N 45TH MIXED-USE

DESIGN REVIEW RECOMMENDATION

DPD #3014098

ALTERNATE CORNICE STUDY

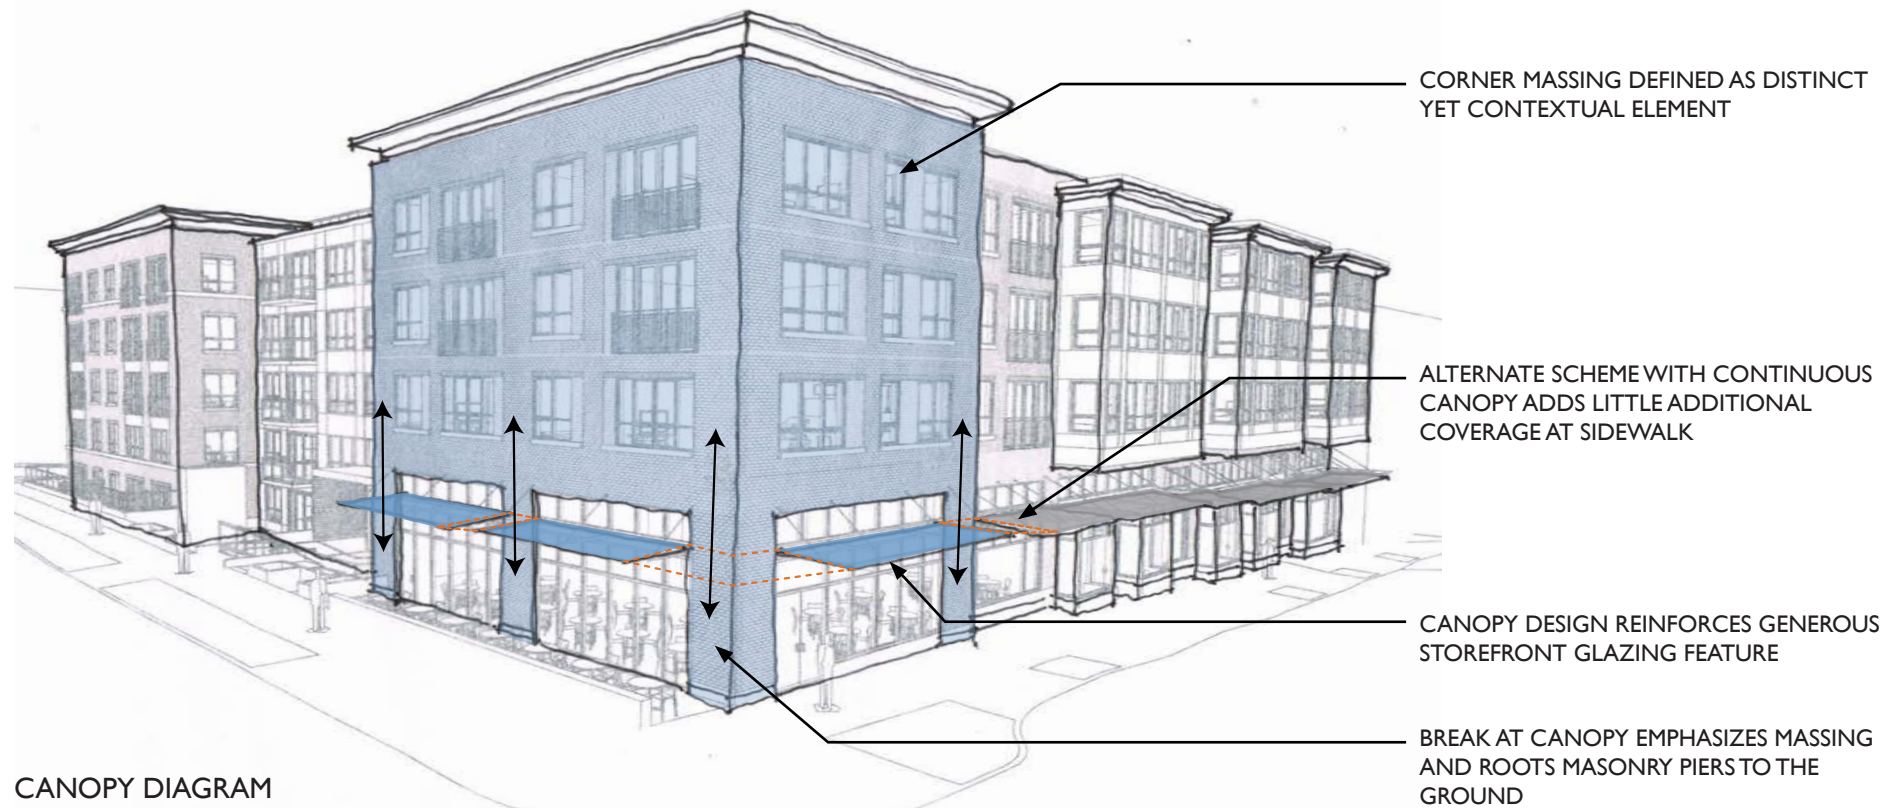
This design study explored different cornice options for the corner massing at N 45th Street and Interlake Avenue N as well as the corner massing at N Allen Place and Interlake Avenue N. Additionally, the design team explored using different cornice features at these two corner massings but preferred the approach of unifying the design with a single cornice element. This strategy balances the traditional building composition along Interlake Avenue N to bookend the central entry courtyard. The selected cornice feature is closely related to Cornice Study #1. Additionally, this element strongly relates to the cornice of the bays along N 45th Street to provide greater design cohesion.

CANOPY COVERAGE STUDY

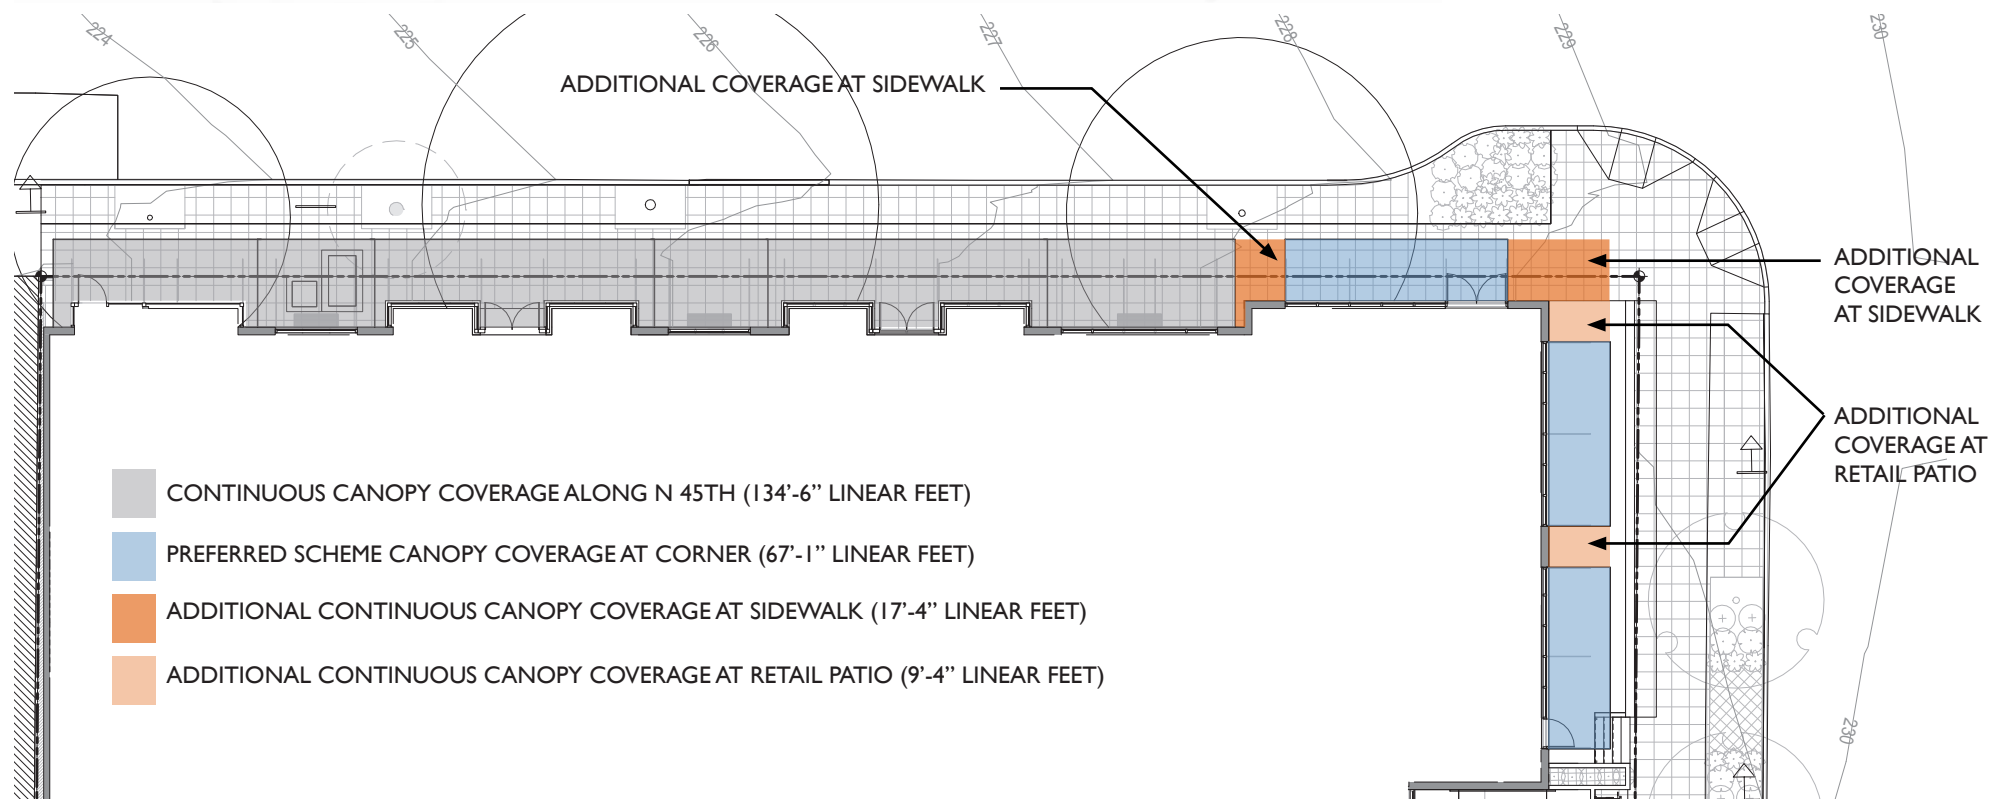
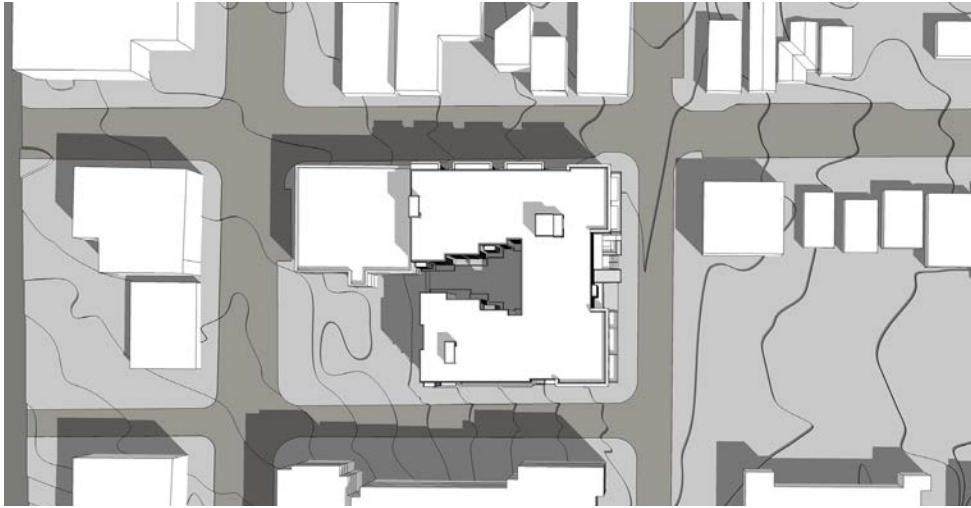
This study analyzes two schemes for the overhead weather protection at the corner of N 45th Street and Interlake Avenue N. The design team's preferred scheme interrupts the continuous canopy at the corner massing masonry piers. This strategy emphasizes the masonry's connection to the ground, further articulates the generous storefront glazing elements, and distinguishes the corner retail and patio. This scheme best enhances the design concept of the corner massing as unique yet contextual anchor of the project. The design team also explored an alternate scheme that maintains a continuous canopy around the corner massing and above the retail patio. This scheme adds little additional overhead weather protection to the sidewalk. Furthermore, this scheme diminishes the concept of a distinct corner massing.

DEPARTURE #1 ABUTTING SIDE SETBACK

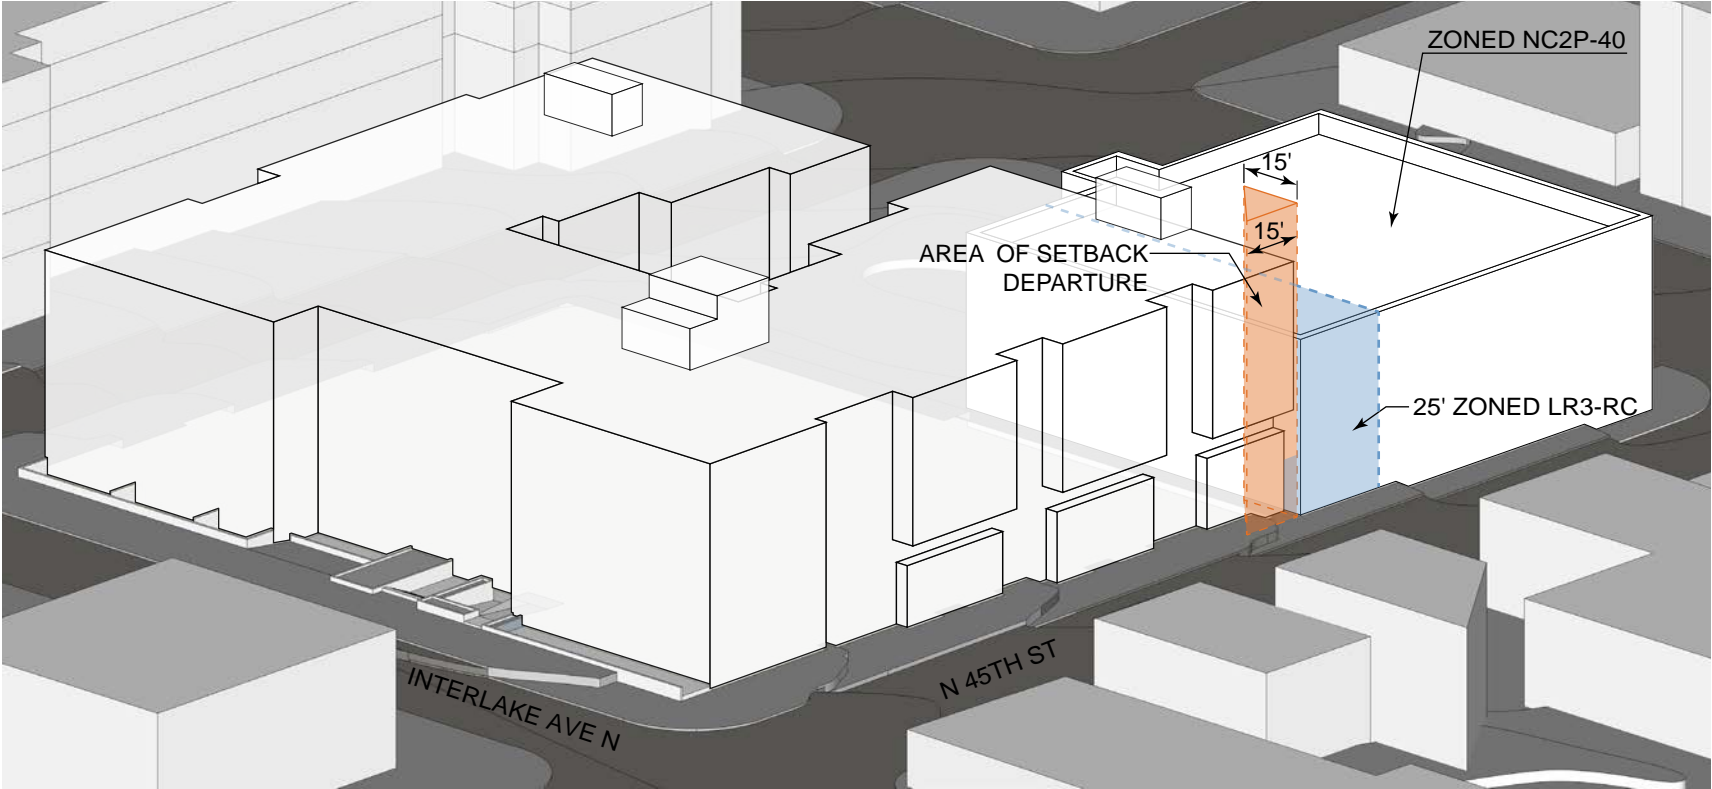
NC2P-40 ZONING CODE CITATION	CODE REQUIREMENT	PROPOSED DESIGN DEPARTURE	RATIONALE FOR DEPARTURE
#1 ABUTTING SIDE SETBACK SMC 23.47A.014.B.1	15'X15' corner setback required for a commercial lot, abutting a side lot line in a residential zone. No development is allowed within setback.	A 0' setback along the common property line shared by the Walgreen's Building to match the adjacent existing zero lot line condition.	The property to the west of the project site is zoned NC2P-40 except for a 25' wide by 95' long portion running along our west property line and the east property line of our neighbor. This 25' wide area is zoned LR3-RC, a vestige of long outdated zoning that doesn't represent current conditions or the boundaries of the existing Walgreen's property. A contract rezone of our site to NC2P-40 would leave this 25' wide slot of LR3-RC zoning isolated and of limited developable value. The neighboring property is fully developed and currently occupied by a 3 story, approximately 40'+ tall structure with no setback along their west property line. The existing 3 story structure was constructed in the mid 1980's and is currently occupied by Walgreen's pharmacy on the ground floor and commercial offices on the upper two floors. In keeping with the goals of the Wallingford Neighborhood to reinforce the existing streetscape along 45th and to providing a vibrant retail storefront character along 45th we are requesting that the setback requirements be mitigated and the continuous street/wall massing be reinforced. The goal of this project is to bridge the recent retail development to the west to the vibrant pedestrian retail to the east.

DEPARTURE #2 ABUTTING SIDE SETBACK

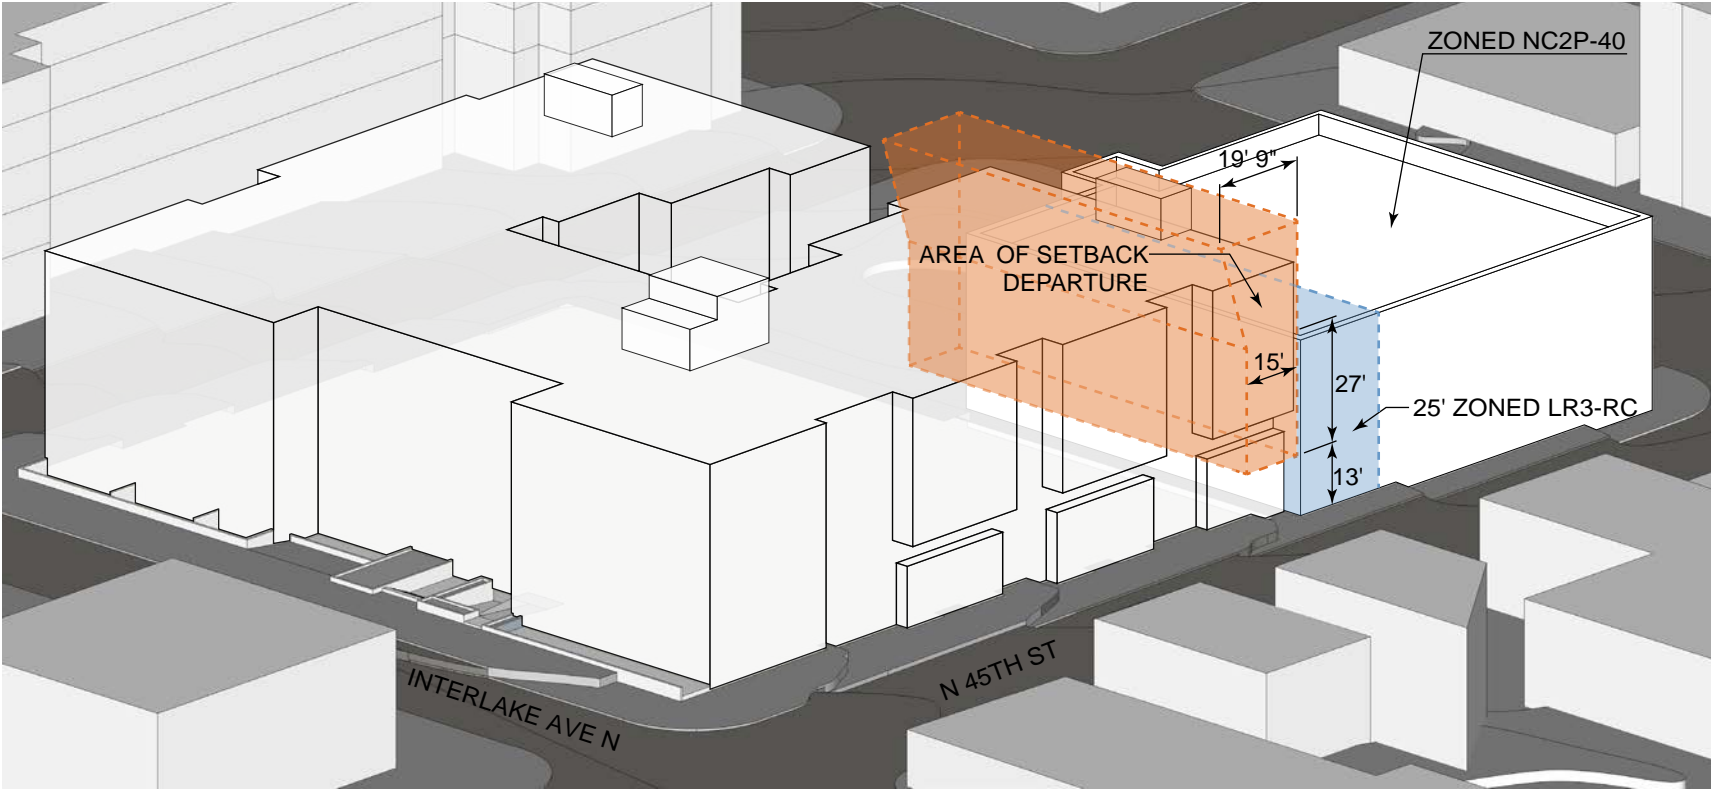
#2 ABUTTING SIDE SETBACK SMC 23.47A.014.B.3.	A 15' setback is required for that portion of the structure above 13' when a portion of the proposed structure contains a residential use. For each portion above 40' in height, additional setback at the rate of 2' of setback for every 10' by which the height of such portion exceeds 40'.	A 0' setback along the common property line shared by the Walgreen's Building to match the adjacent existing zero lot line condition.	See rationale for departure above.

DEPARTURE #3 RESIDENTIAL USES AT STREET LEVEL
DEPARTURE #4 RESIDENTIAL USES AT STREET LEVEL

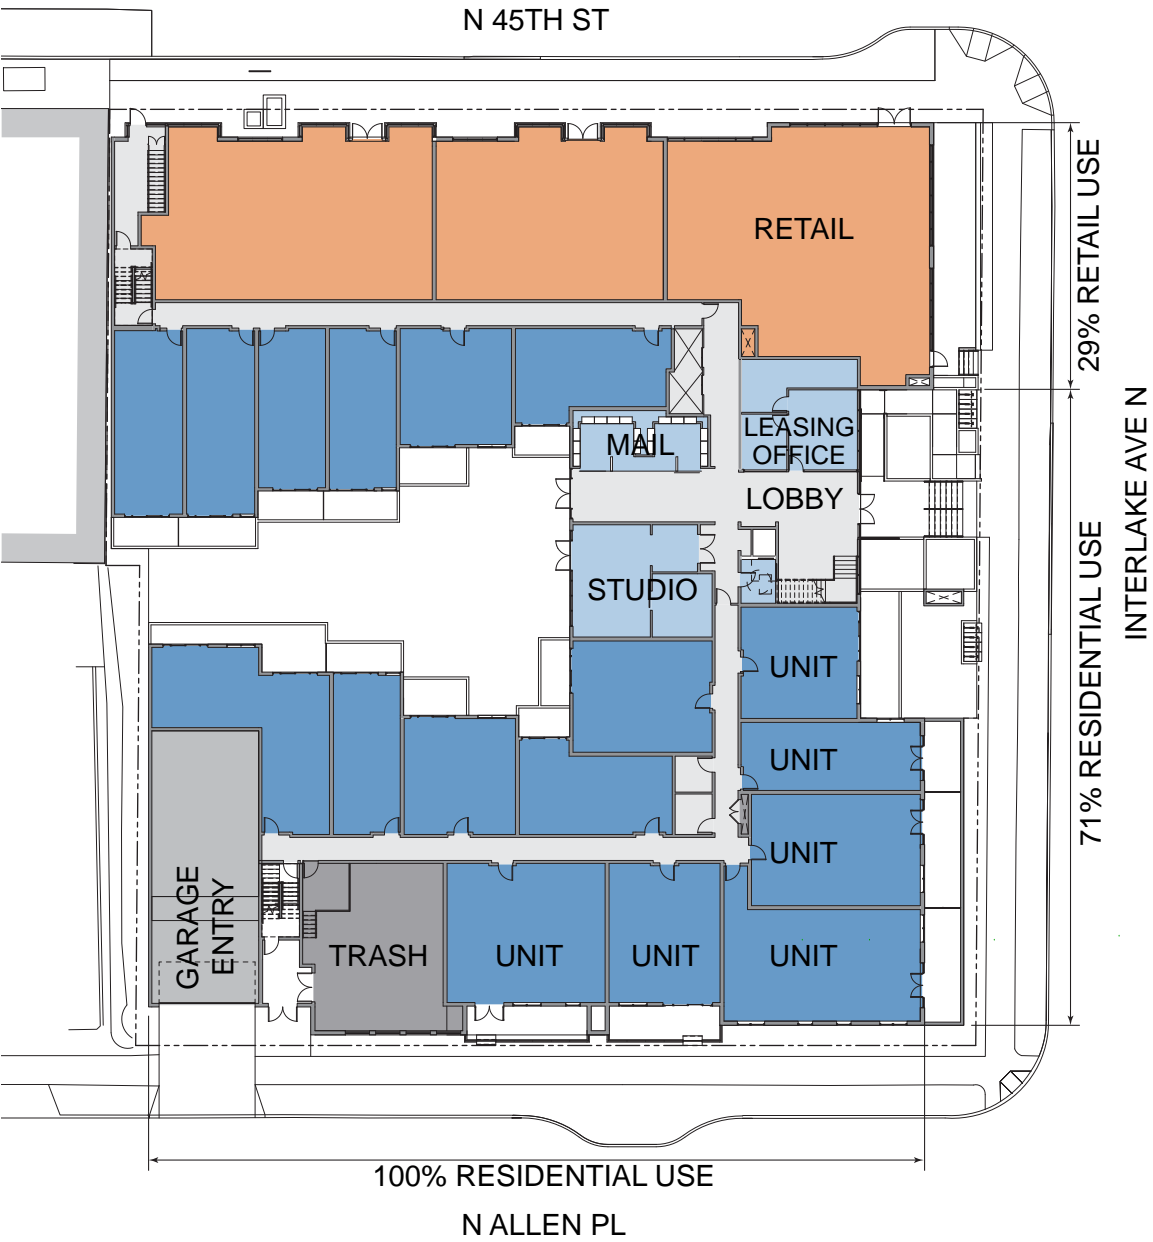
#3 STREET LEVEL USES - RESIDENTIAL USES AT STREET LEVEL SMC 23.47A.005.C.1	Residential uses may not occupy, in the aggregate, more than 20% of the street-level street-facing facade in the areas shown on Maps 1 through 60 in Map Book A. Map 5 includes the five parcels fronting N Allen Place.	100% residential street-level street-facing uses along N Allen Place to match the residential character of the housing located across N Allen Place to the south.	100% residential uses along N Allen Place are proposed to match the residential use of University House to the south and the existing residential character of the street. Ground level units with patios along N Allen Place will further establish the neighborhood character of this street.

#4 STREET LEVEL USES - RESIDENTIAL USES AT STREET LEVEL SMC 23.47A.005.C.1	Residential uses may not occupy, in the aggregate, more than 20% of the street-level street-facing facade in the areas shown on Maps 1 through 60 in Map Book A. Map 5 includes the two parcels fronting Interlake Avenue N.	71% residential street-level street-facing uses along Interlake Avenue N to transition to the residential neighborhood to the south.	Interlake Avenue N creates a transition from the vibrant retail uses of N 45th Street to the quieter residential neighborhood located to the south. In response, the proposed project anchors the corner of N 45th Street and Interlake Avenue N with neighborhood retail. Directly south of the retail along Interlake is an entry courtyard leading to a double-height lobby and leasing office. The lobby and leasing office comprise one-third of the residential uses along Interlake. The residential use then transitions to ground-level units with sunken patios to continue the existing neighborhood pattern to the south.

DEPARTURE #5 STREET-LEVEL FACING FACADES

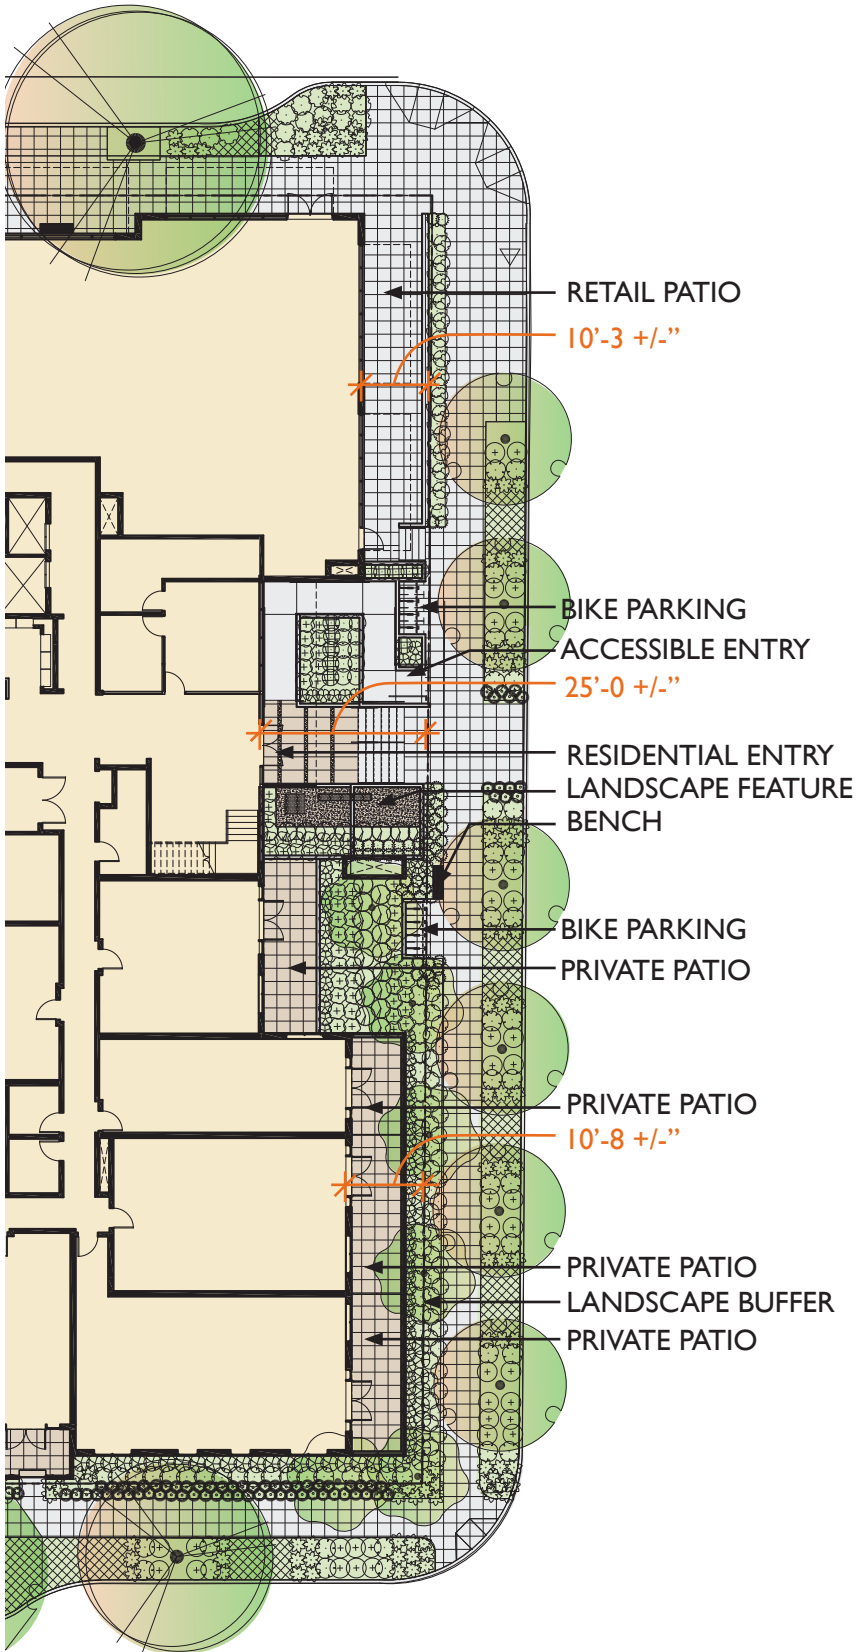
NC2P-40 ZONING CODE CITATION	CODE REQUIREMENT	PROPOSED DESIGN DEPARTURE	RATIONALE FOR DEPARTURE
#5 STREET-LEVEL DEVELOPMENT STANDARDS - STREET-LEVEL FACING FACADES SMC 23.47A.008.A.3	Street-level street-facing facades shall be located within 10 feet of the street lot line unless wider sidewalks, plazas, or other approved landscaped or open spaces are provided.	10.25'+/- setback at the retail located along Interlake Avenue N. 25'+/- setback at the entry courtyard located along Interlake Avenue N. 10.67'+/- setback at the unit patios located along Interlake Avenue N.	The building has been setback further than 10' along Interlake Avenue N to create building modulation, pedestrian amenities, and to accommodate the transition in character at the pedestrian level from N 45th Street to the neighborhood to the south. At the corner, the building is setback slightly more than 10' to accommodate a retail patio with cafe seating. To define the transition towards a residential character, the building mass is setback further from the sidewalk to create a prominent residential entry with landscaping, seating, and a ground-level unit patio. Further to the south the building is setback just over 10' to provide spacious unit patios with a landscape buffer from the sidewalk and to meet the provisions of code section 23.47.008.D.2.
